**Re: Response to State Environmental Policy Act (SEPA) Comments on the Westside Solar Project (CU-19-00003)**

Thank you for providing your review comments on the Westside Solar Project (Project). This letter is intended to provide specific responses to comments included in your letter, dated December 16, 2019.

*Photo 1. Summertime photo from a solar energy facility owned by Heelstone in Oregon. This photo is intended to demonstrate typical vegetative cover conditions—an approved native species seed mix can be used in the array area to provide cover and foraging habitat for small mammals and birds.*

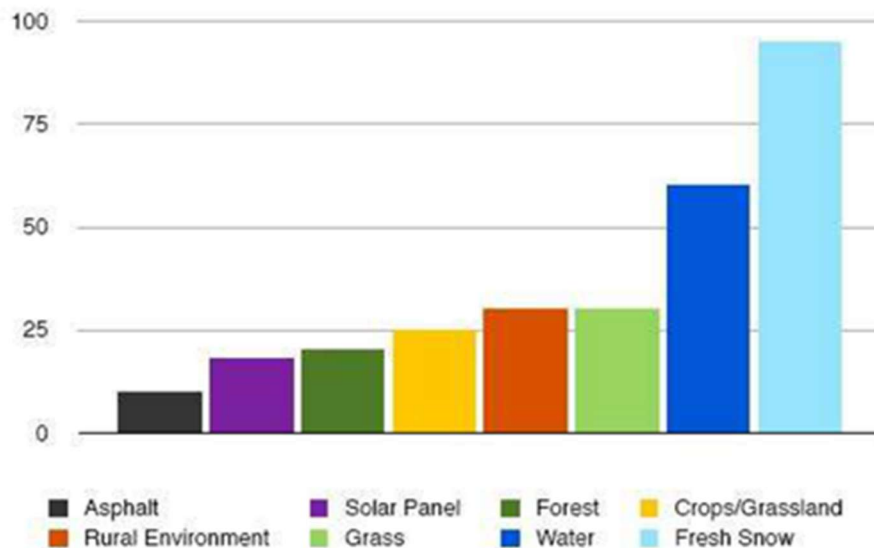
*Wetland buffers act to filter surface runoff, reduce erosion, screen adjacent noise, light and activity, and protect critical habitat for wetland dependent species. Our review of available studies indicates that effective buffer widths range from 50 feet to 250 feet, depending upon the values provided by the wetland, the topography, soils, existing vegetation, and the proposed adjacent land use. In some instances, enhancement of an existing buffer, such as planting of native vegetation, or construction a fence, can improve the protection of wetland functions.*

*Wetland 2, which will not have any direct impacts, has a proposed 25 foot buffer. Ecology recommends the County to use their widest Category II wetland buffer. Solar farms are considered a high land use intensity and to properly buffer a Category II wetland with a habitat score of 7, Ecology's guidance requires a 150 foot wide buffer. The County's Critical Area Ordinance for Category II wetlands, requires between 25 to 100 feet of upland buffer. Therefore, Ecology would recommend the widest buffer the County's CAO authorizes, which is 100 feet landward of the wetland boundary.*

*Wetland 1, is a Category I wetland with special characteristics (aspen stand) and a high score of functional habitat (8). This wetland will be impacted; therefore Ecology can require our regulatory buffer guidance to be used. A Category I wetland with a Habitat Score of 8, and surrounded by a high land use intensity would require a 200' wide buffer. However, there is opportunity to reduce the buffer width if the two items in Chapter 6.6.1.1 of Wetland Mitigation in Washington State, Part 1 can be met.*

The National Electrical Code requires a Project like Westside Solar to have a fence around the panels, but the Project has introduced several elements to make this as favorable to wildlife as possible. It will incorporate a woven-wire, wildlife-permeable fence with 1-foot by 1-foot cutouts to allow larger animals through. The fence will be 8 feet tall with no barbed wire to prevent injury to larger game that may attempt to jump a lower fence or get caught in anti-climbing devices. In addition, the majority of the approximately 26 fenced acres will be naturally vegetated and can be overseeded

with an approved native seed mix to provide cover and, potentially, foraging habitat for small mammals and birds.

Apart from the access road, the majority of the area within the fence will not be graded, compacted, filled, or paved. Therefore, we anticipate that the area will have similar ecological and hydrologic functions as does the current pasture area. The panel racking system will be supported on piles, metal posts driven into the ground without concrete footings (Photo 1).
